**GOVERNMENT OF THE DISTRICT OF COLUMBIA**  
**DEPARTMENT OF TRANSPORTATION**

**MEMORANDUM**

**SUBJECT:** ZC Case No. 16-10 – 400 Florida Avenue NE

Figure 1 Site Design and Access (Source: SK&I Architecture 10/7/16)

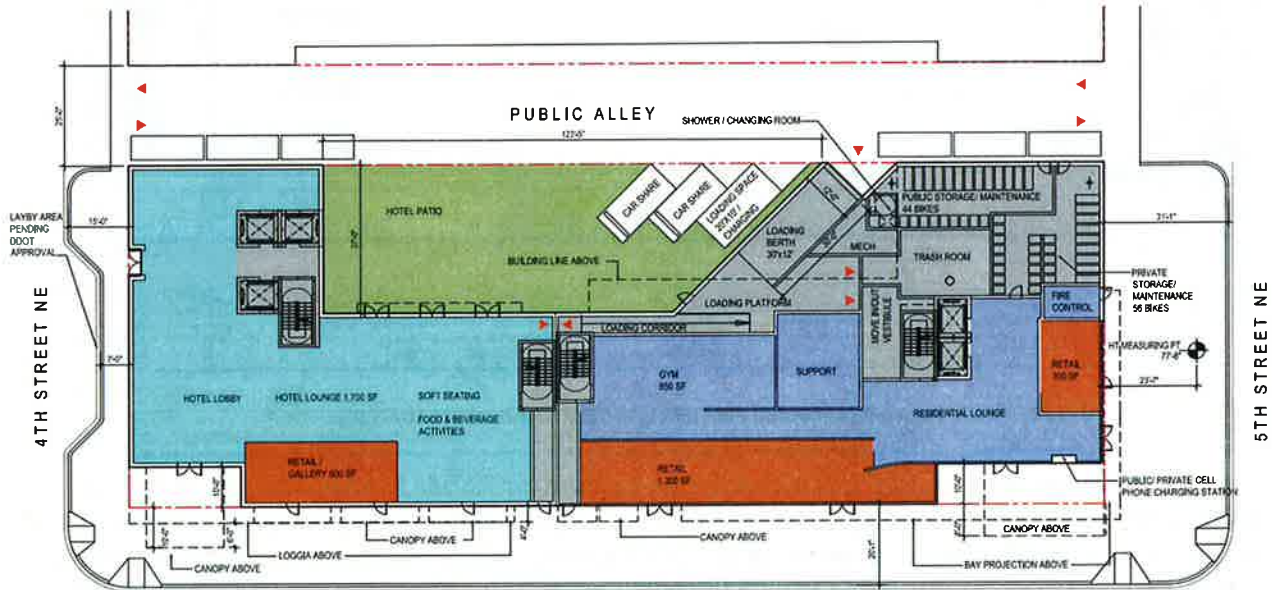
The Zoning Regulations require that the Applicant provide at least one (1) 55-foot berth for the residential component and one (1) 30-foot berth for the hotel component plus a 20' service space for each use. As shown in Figure 1 below, the Applicant proposes one 30-foot loading berths to be used for both the hotel and apartments and one shared service/electric vehicle space. The Applicant estimates the site will generate approximately 6-7 trucks per day including trash, mail, hotel deliveries, and residential move-ins. DDOT estimates that twice that figure, approximately 12 to 14 trucks per day, is more likely to be expected. DDOT finds that hotel uses typically generate approximately 6 truck trips daily for items such as linens, beverages, food, paper, and trash. The hotel is proposed to include other loading-intensive uses such as restaurant, professional office space, and a coffee bar. In addition, residents moving in and out of the residential component will also need to utilize a loading berth.

DDOT finds the loading management plan to be insufficient and, due to the expected volume of truck trips, a second 30' loading berth is required to serve the site. In addition, a loading management plan is needed to address accommodations for larger trucks expected to serve the restaurant and coffee bar uses.

The Applicant proposes 106 secure long-term bicycle parking spaces in a bicycle room on the ground floor, which exceeds District Code requirements, including 60 spaces for residents and 46 spaces and a shower/changing area for public use. Additional description is needed regarding the operations and eligibility criteria of the public use spaces. The Zoning Regulations also require a total of 8 short-term bicycle parking spaces adjacent to the site. The Applicant is proposing 16 short-term bicycle parking spaces, specifically inverted U-racks in highly visible locations. Circulation between the bicycle room and each use within the development is unclear. As shown in Figure 1, an interior connection between the bicycle room and the various lobbies is not provided.

- Implement the proposed TDM plan outlined in the Applicant's Comprehensive Transportation (CTR);
- Revise the site plan to include one (1) additional loading berth 30' in length;
- Provide interior connections from the long-term bicycle parking rooms to the hotel and residential lobbies;
- Strengthen the loading management plan to include a contingency for trucks larger than 30' in length; and
- Reconstruct the curb ramps and stripe highly visible crosswalks on Morse Street NE at the intersections with 4<sup>th</sup> and 5<sup>th</sup> Street NE to provide pedestrian connections to the off-site parking, if not already constructed by others.

Figure 2 Landscape Plan (Source: SK&I Architecture 10/7/16)

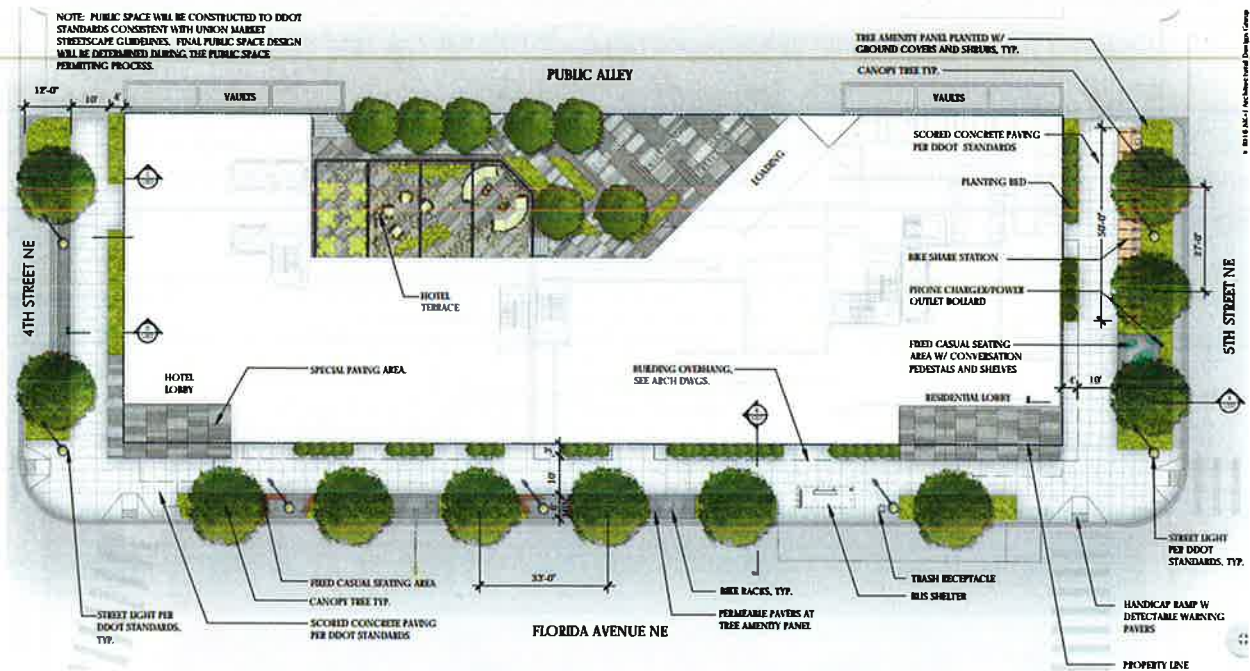
All proposed elements in public space, including components shown on the conceptual plan (Figure 2), require public space permits. As the plan has not received public space approval, it may need to be adjusted as it progresses through the public space permitting process. The elements shown in the conceptual plan are generally consistent with approved uses in public space.

- The proposed lay-bys on 4<sup>th</sup> and 5<sup>th</sup> Street NE are not supported by DDOT. Note that some graphics provided by the Applicant show lay-bys on both streets or neither street or other graphics like Figure 2 only show one on 4<sup>th</sup> Street NE;

- The sidewalk width on Florida Avenue, NE should be 10-feet wide and the sidewalks on 4<sup>th</sup> and 5<sup>th</sup> Street NE should be at least 8-feet wide. Note that the Applicant is showing different measurements on different graphics. Some of the provided graphics only show 7-foot sidewalks on 4<sup>th</sup> Street NE while others like Figure 2 show 10-foot sidewalks.

- Reduce the amount of special paving in front of the main entrances to a maximum of twice the width of the doorway and 1/3 the width of the sidewalk within public space.

- Revise the site plan to remove the proposed lay-bys from both 4<sup>th</sup> and 5<sup>th</sup> Street NE and valet staging from 5<sup>th</sup> Street NE;

- Construct sidewalks to be at least 8-feet wide on 4<sup>th</sup> and 5<sup>th</sup> Street NE and at least 10-feet wide on Florida Avenue NE;
- Location of the 16 proposed short-term bicycle parking spaces, preferably inverted U-shaped racks, in highly visible locations near building entrances;
